## **NPT Track 2 Supplemental Q 9, EXHIBIT 6**

**CONCLUSIONS REGARDING EXPECTED NPT WETLANDS IMPACTS BASED ON  
FIELD OBSERVATIONS OF 4 SITES IN DEERFIELD, MARCH 30, 2017**

**NPT Track 2 Supplemental Q 9, EXHIBIT 8**

**SITE 4: Emergent Wetland south of Parade**

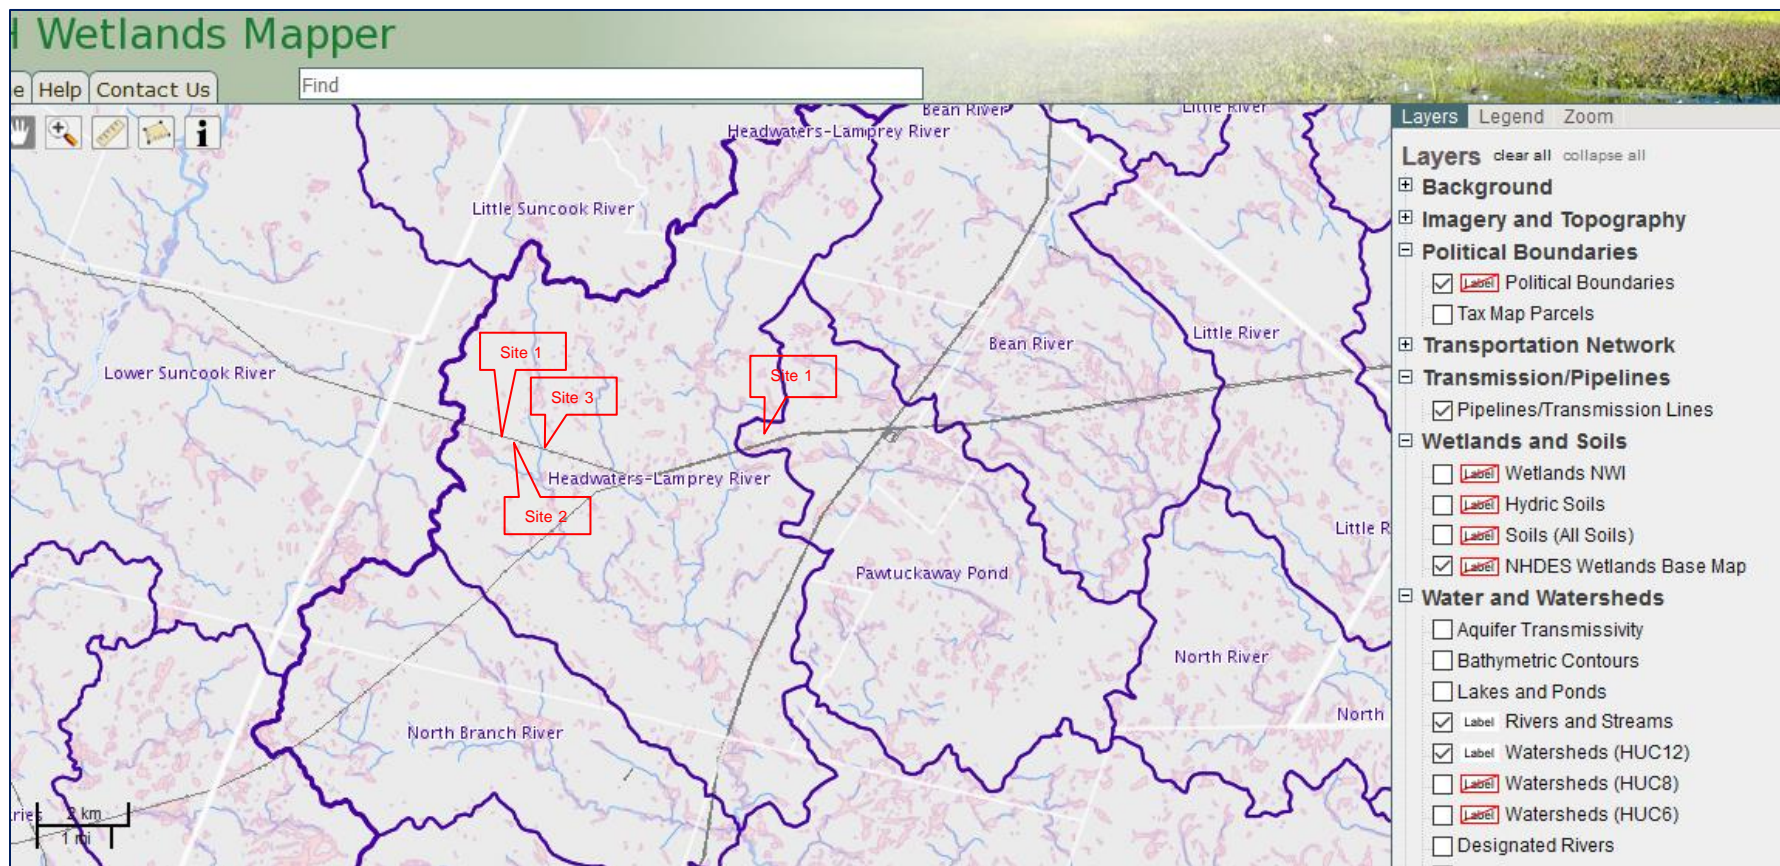
Observed a beaver lodge with signs of recent activity: new mud & branches and recent beaver foraging in adjacent upland north of proposed structure #3132-300. A proposed construction pad appears to extend over or lie next to, this active lodge.
